SECOND AND THIRD READING SUMMARY SHEET

ZONING CASE NUMBER: C814-2018-0121 - 218 South Lamar

ZONING CHANGE REVIEW SHEET

CASE: C814-2018-0121 -- 218 South Lamar

4-Lane Divided, 60' Curb-to-Curb
Back-of-Curb Condition F
Barton Springs Road to Riverside Drive

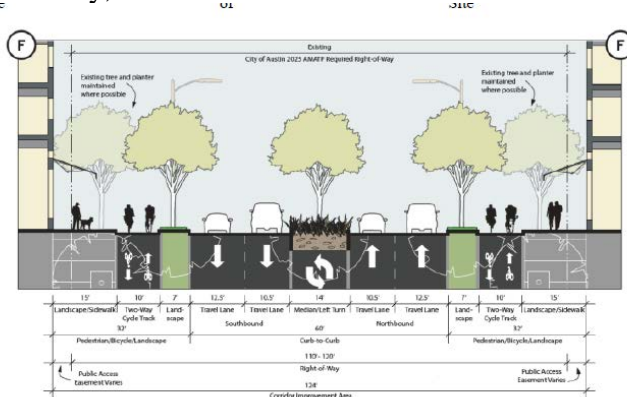
TR2. Include the below streetscape in the land use plan. Contact this reviewer for a more legible copy of it if necessary. This project is adjacent to a street that has been identified in Austin's Corridor Mobility Program (S Lamar). The sidewalk and bicycle facilities shall comply with the required cross-section at the time of the site plan application. The cross section that will be required is shown below. Find additional information about the Corridor Mobility Program here: <https://data.austintexas.gov/stories/s/Corridor-Mobility-Program/gukj-e8fh/>. Any proposed curb relocations on S Lamar requires coordination with the Corridor Planning Office and Bicycle Program. The cross section will include a 7' planting zone with street trees, a 10' two-way cycle track, and a 15' clear zone all behind curb. Additionally, a protected intersection will be required at Toomey, to be reviewed at the time of Site Plan.

**CONCEPTUAL DESIGN -
7TH FLOOR**

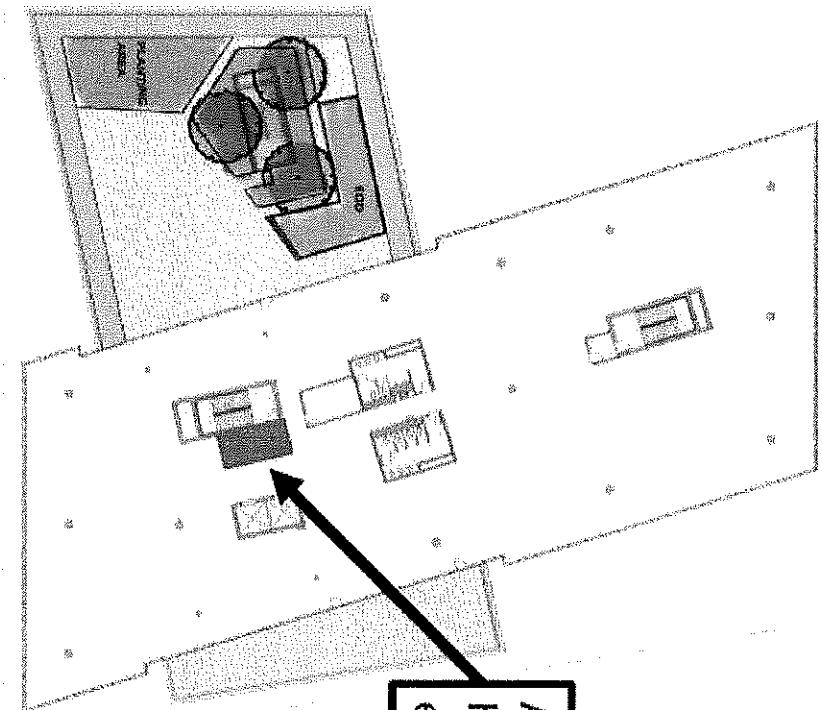
U0: Attached drawings do not show elevator over run. Please provide.
